RE: Ramp NS-W, Hwy. 115/7A I.C.  
W.P. 128-86-00 (refer to W.P. 74-70-05)  
Hwy. 115, District #7, Port Hope

**foundation  
investigation and  
design report**

Hwy. 7A Underpass

HIGHWAY 7A UNDERPASS  
GENERAL LAYOUT

Plan  
NTS

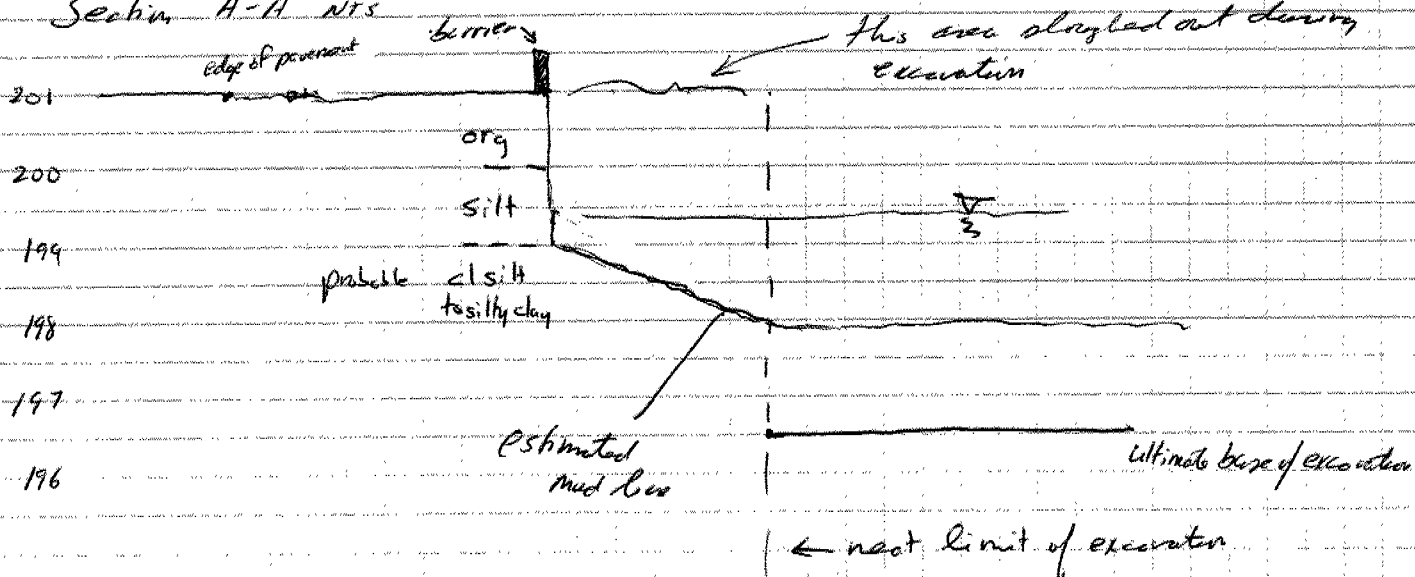
- the contractor felt that road protection required and halted his operation pending a decision from MDV

- the contractor proposed moving his sheet pile box caisson from west side of road to east side

- the shoring could be driven H piles & lagging or alternatively sheet piles

# RECOMMENDED SUBEXCAVATION DETAIL

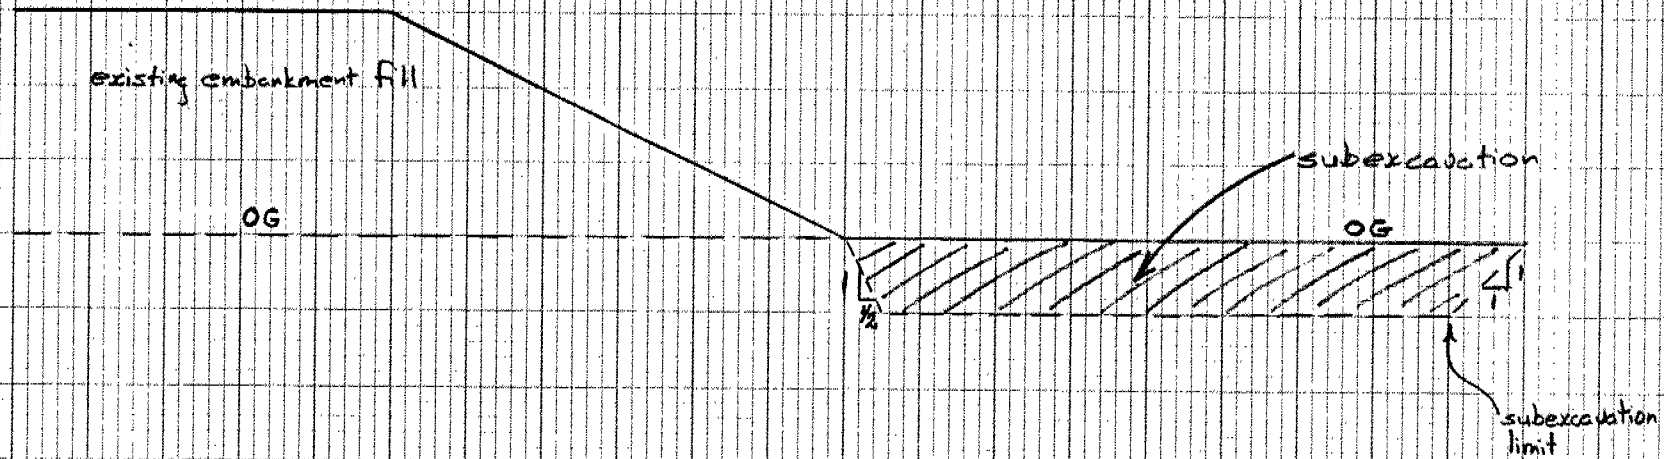
- 1) Based on the available drawings, it is difficult to review the berm design. It is our understanding that additional X-sections will be available for the contract. When these become available, please provide us with representative X-sections for review. Preferably, the representative X-sections should consist of the highest and lowest grades, where berms are required, for each ramp/approach.
- 2) Concerning the subexcavation detail in the typical sections, we are concerned
  - a) that the vertical subexcavation indicated will not be attainable due to the soft organic soil.and
  - b) that a vertical cut adjacent to the existing toe of the slope may adversely affect the stability of the existing embankment.

- a) that the subexcavation geometry should be modified as illustrated in the attached sketch. If any distress to the existing embankment results, the subexcavation should be backfilled to 2H:1V and this office should be immediately advised.

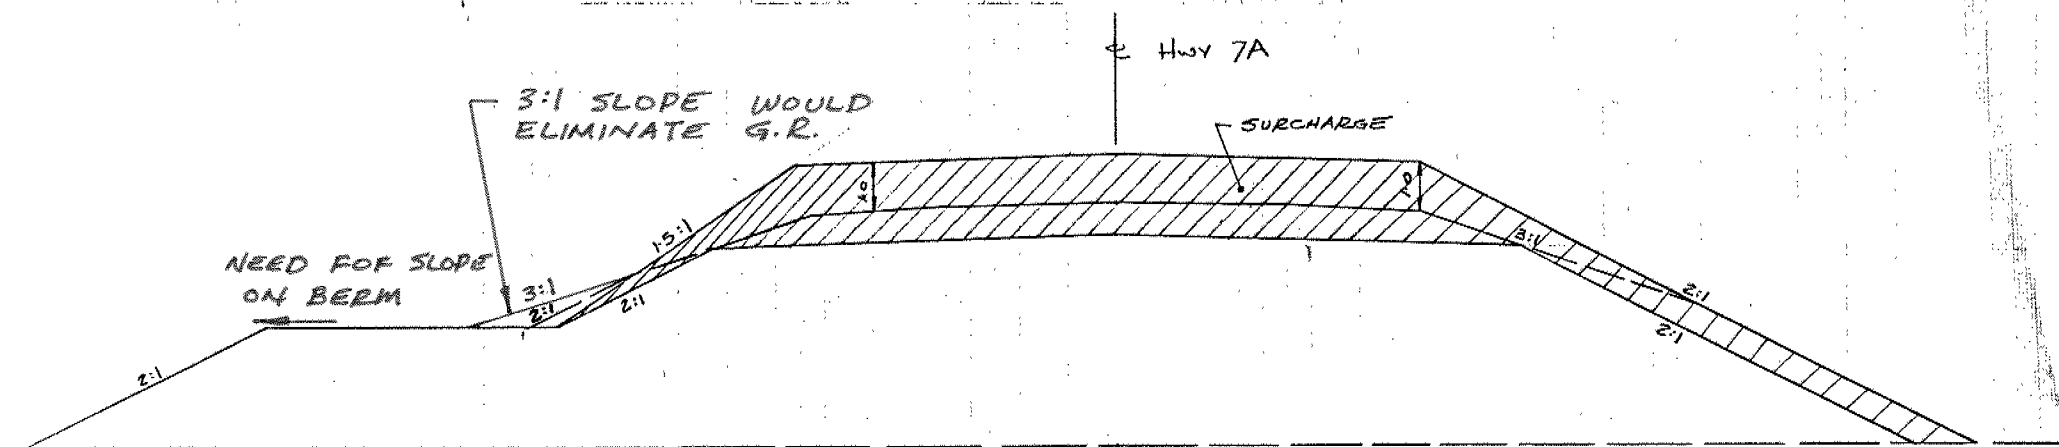
May we please have your comments on the following matters, illustrated on the attached sketch:

- a) The need for a slope on the lateral berms and if required, your recommended %.
- b) Would it be acceptable to grade off the surcharge fill at a 3:1 fill slope on top of the berm to eliminate the need for guiderail.
